Case No. 19/02603/REMMAJ

Location: Land Comprising Field At 446321 456601, New Lane, Green Hammerton, North Yorkshire

Proposal: Reserved Matters Application for the erection of 80 dwellings with Access (within the site), Appearance, Landscaping, Layout and Scale considered pursuant to Outline Permission 17/01446/OUTMAJ

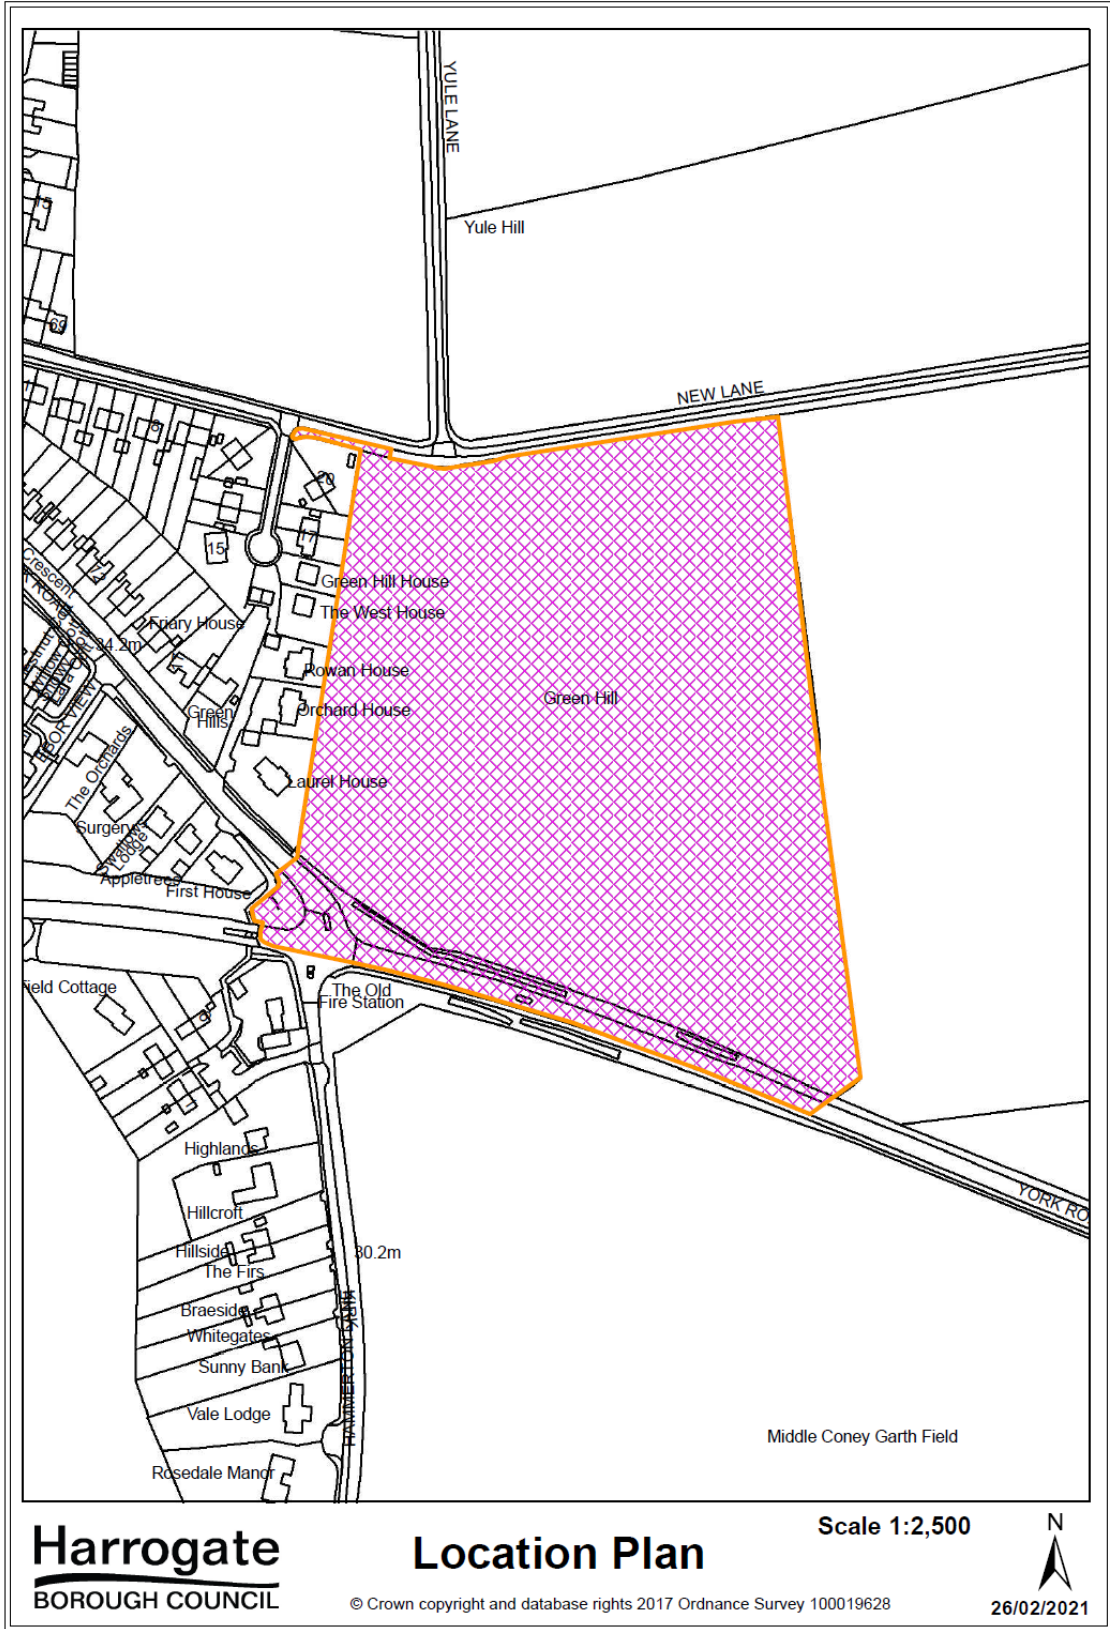
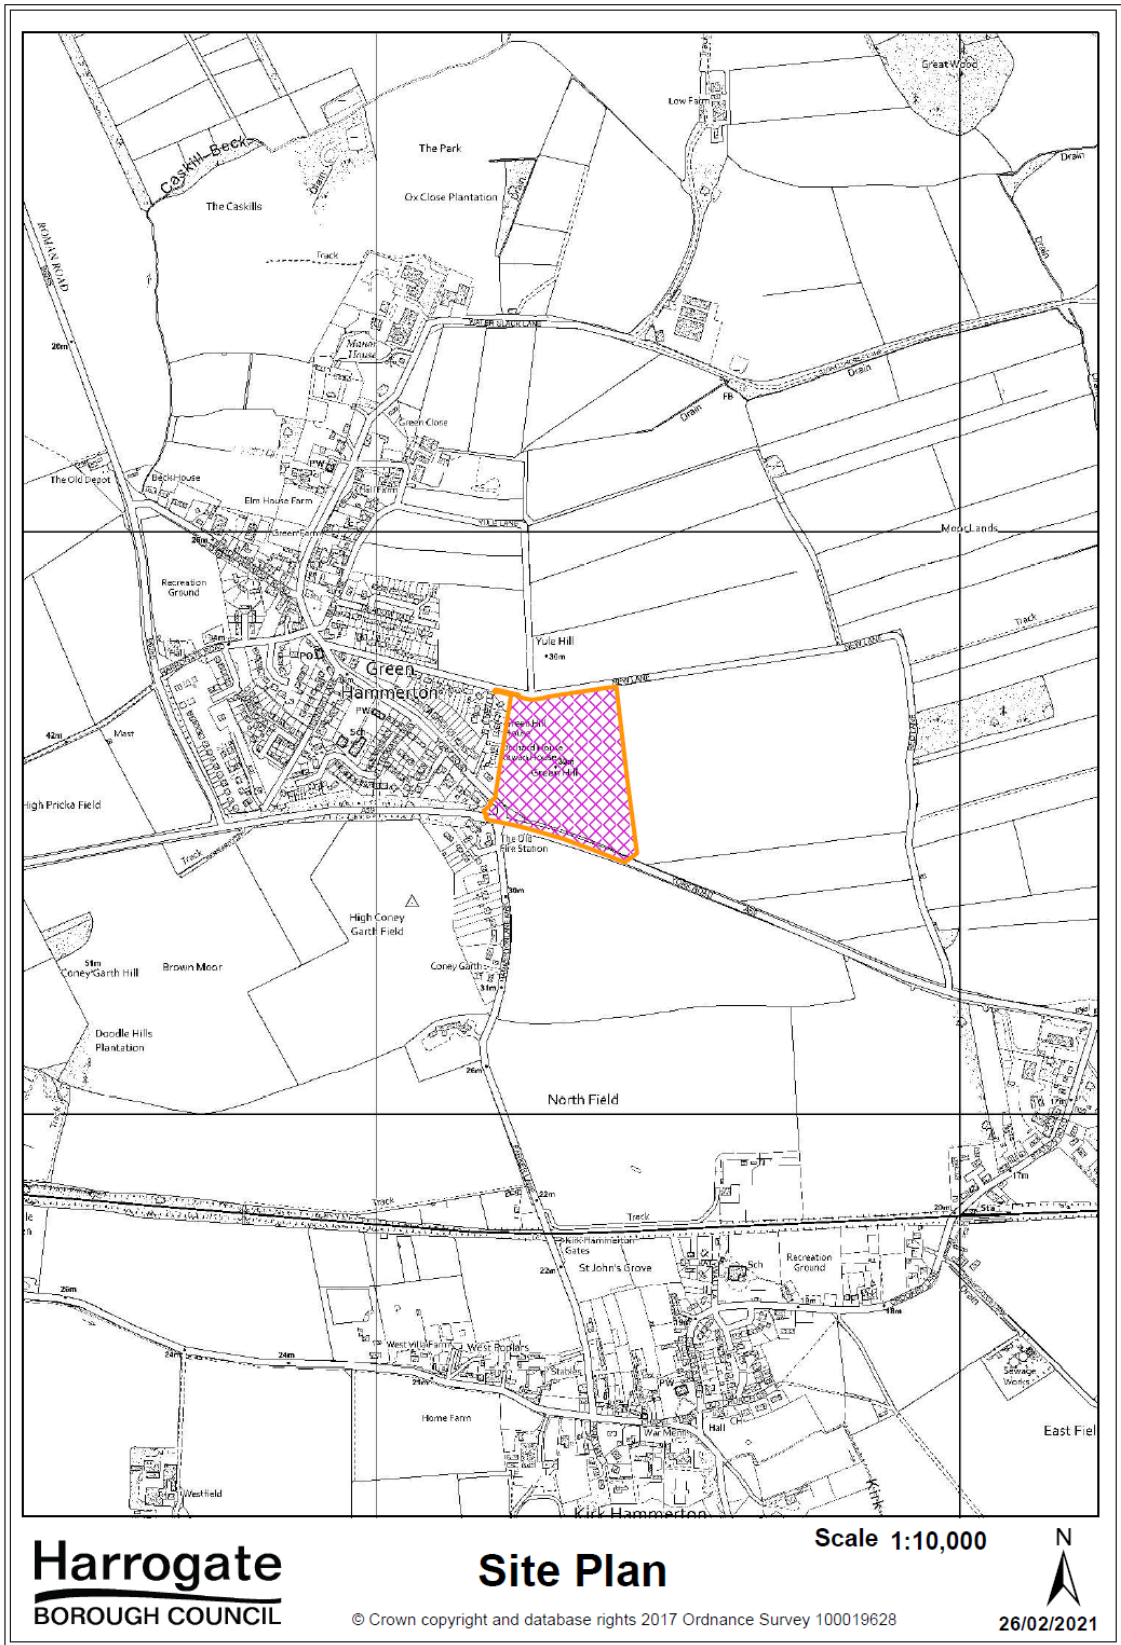
- 4.9 The proposed layout has changed during the course of this reserved matters application so that the built development (aside from underground LPG storage tank and underground pump station) is now confined to the build zone defined on the approved Development Principles Plan. This has in part been achieved by providing more two and three bedroom properties which has reduced the overall build floor area.

- 4.10 A key revision to the layout concerns the western boundary condition. As originally proposed, this side of the site comprised a straight row of 20 houses, mostly in the form of terraced housing which appeared as a solid wall when viewed from the west. Some houses extended into the buffer reserved solely for gardens.

- 4.11 Development on the western side is now reduced to 13 houses which are relocated further away from the site boundary with most having well in excess of 12.5m long gardens. The alignment is broken up with a looser arrangement of houses set within more generous-sized plots, better reflecting the existing pattern of development to the west. This arrangement allows for filtered views through the houses.

4.59 The matters of concern for this application relate to the internal circulation routes within the site. The Highway Authority during the course of the application requested a number of minor alterations to the internal road layout including extending turning heads, vehicle tracking, re-positioning of the LPG underground storage tank as well as more visitor car parking. The latest Site

5.1 NYCC Highways and Transportation: Changes to site layout required including visibility splays; footpath widening; access arrangements to some properties need to be re-considered; New Lane to be used for emergency vehicles only.

- 5.2 Further response: Comments on the revised site layout, including the need to show vehicle tracking; more visitor parking spaces; relocation of underground LPG tank; visibility splays shown with landscaping removed to facilitate splays.

Layout Plan seeks to address these details. All adopted roads would have at least 5.5m wide carriageway with 2m wide footpaths. Appropriate sized turning heads have been provided to the end points of roads. Final comments from the Highways Authority are awaited and will be reported verbally.

- 4.62 At the request of the Parish Council, the latest Site Layout Plan includes 2no. retractable bollards at the New Lane emergency vehicle access point and a timber 'kissing-gate' at the pedestrian access point. Further, Condition 13 of the outline permission stipulates that there should be no vehicular access to the development other than from York Road.
